ADMINISTRATIVE AMENDMENT
 File #04-01474 Project # 100046A
 Building replacement with less square footage. See attached letter w/ conditions.
 Approved by: [Signature]
 DATE: 1/28/05

NO.	DATE	REMARKS	BY
REVISIONS			
		PASEO DEL NORTE AND GOLF COURSE WAL-MART NEIGHBORHOOD MARKET #317-00 8511 GOLF COURSE RD. NW	DRAWN BY: rwm
		AMENDED SITE PLAN FOR BUILDING PERMIT	DATE: 12-01-2004
		ALBUQUERQUE NEW MEXICO	2387SPB-11-12-04X
			SHEET # 7 OF 27
			JOB # 230087
ENGINEER'S SEAL		RONALD R. BOHANNAN P.E. #7868

Request: Administrative Amendment to an Approved Site Development Plan for Building Permit for Parcel H-6A1A-1 and H-6A1A-2 Riverview. Total of 6.4955 acres.

FRONT ELEVATION

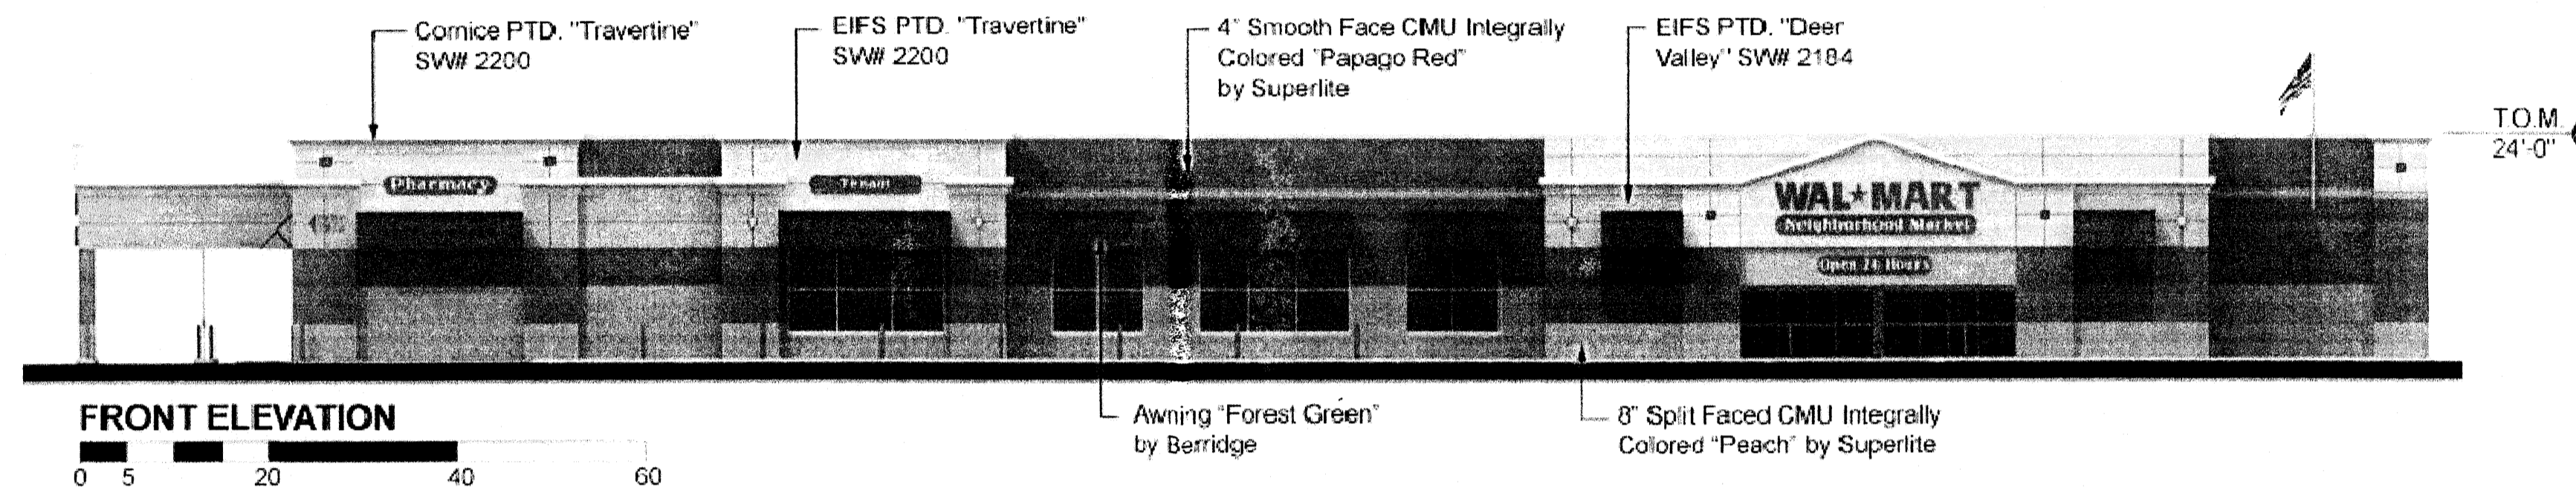
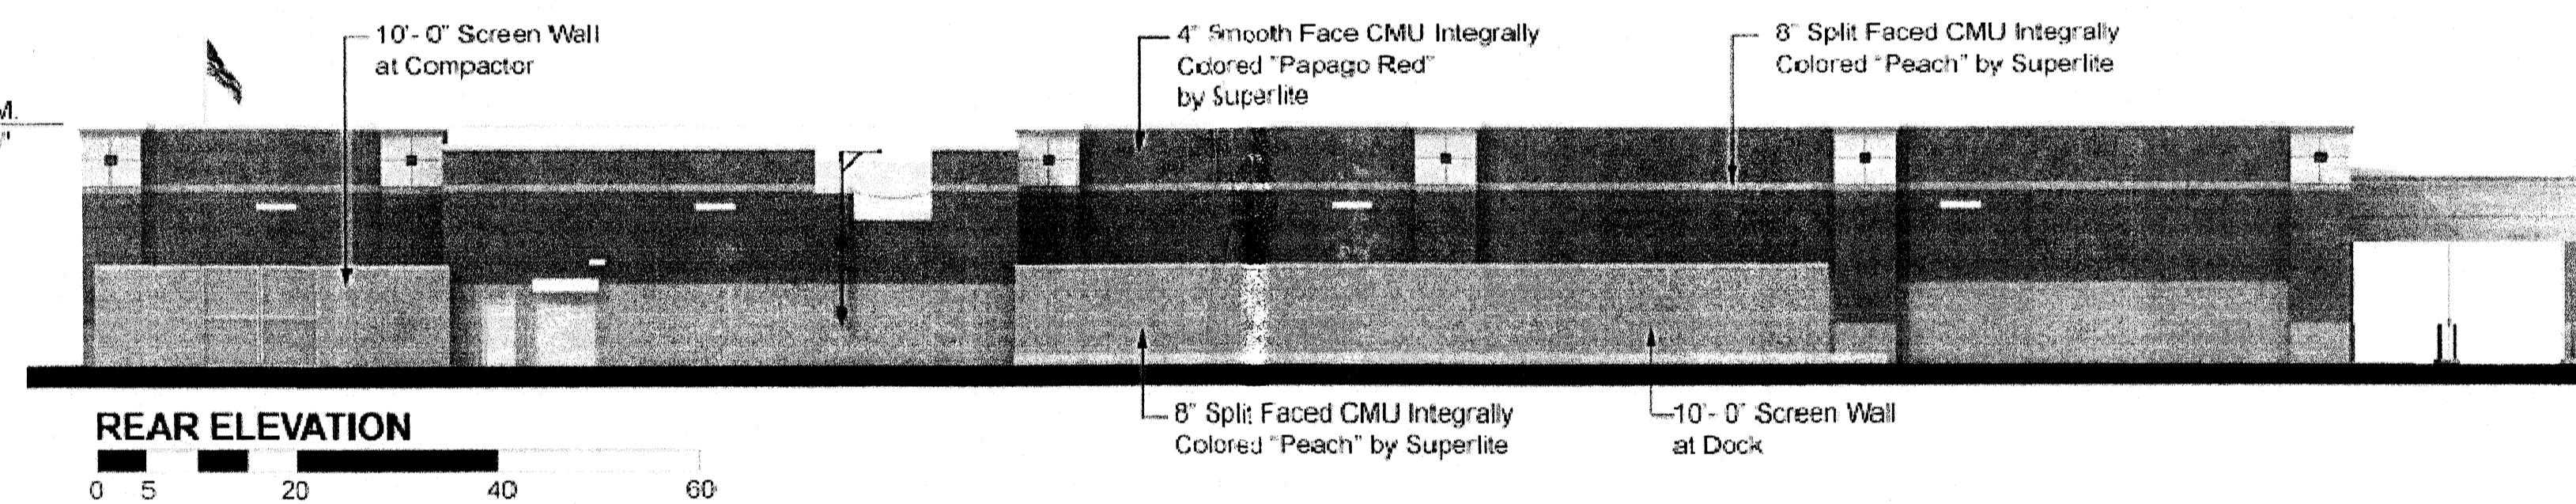
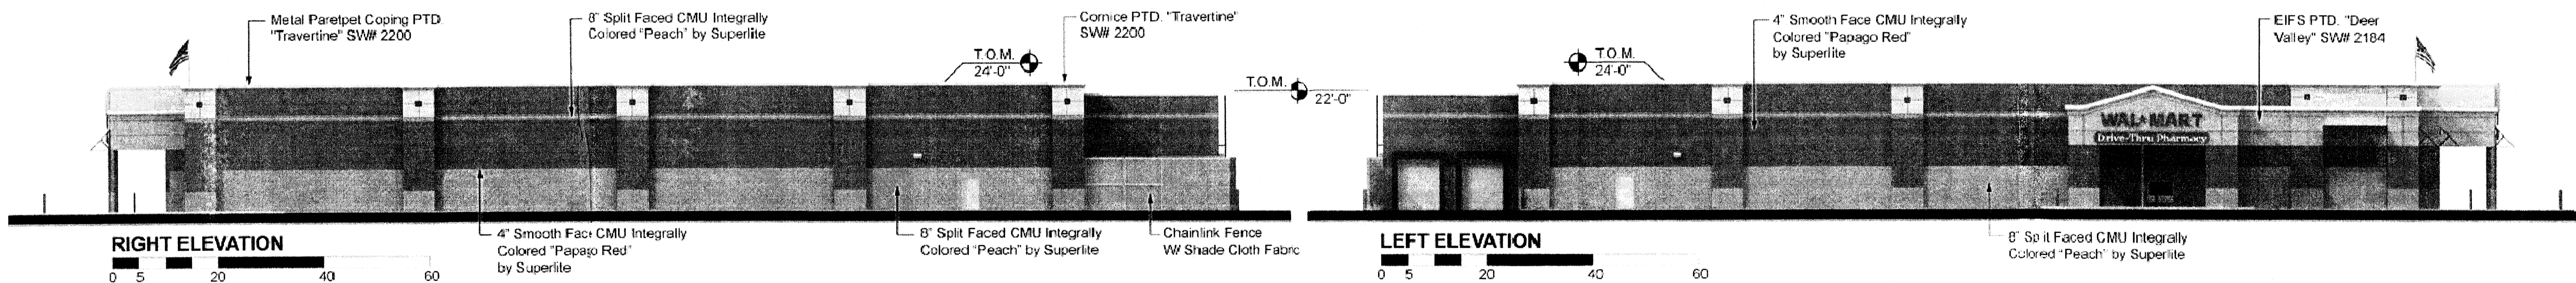
- THE FOLLOWING CHANGES SHALL BE MADE TO THE ELEVATIONS, TO THE SATISFACTION OF THE PLANNING DEPARTMENT, BEFORE FINAL DRB SIGN OFF:
 - 70% OF THE BUILDING MATERIALS SHALL BE SPLIT FACED CMU BLOCK, AS IS CONSISTENT WITH THE "PAD ARCHITECTURE STANDARDS."

- A NOTE SHALL BE ADDED TO THE ELEVATIONS WHICH INDICATES THAT ALL GUIDELINES OF THE "PAD ARCHITECTURE STANDARDS" SHALL BE FOLLOWED.
 - A NOTE SHALL BE ADDED TO THE "PAD ARCHITECTURE STANDARDS" WHICH STATES VINYL COATED PLASTIC REFLECTIVE TYPE AWNINGS SHALL NOT BE PERMITTED.
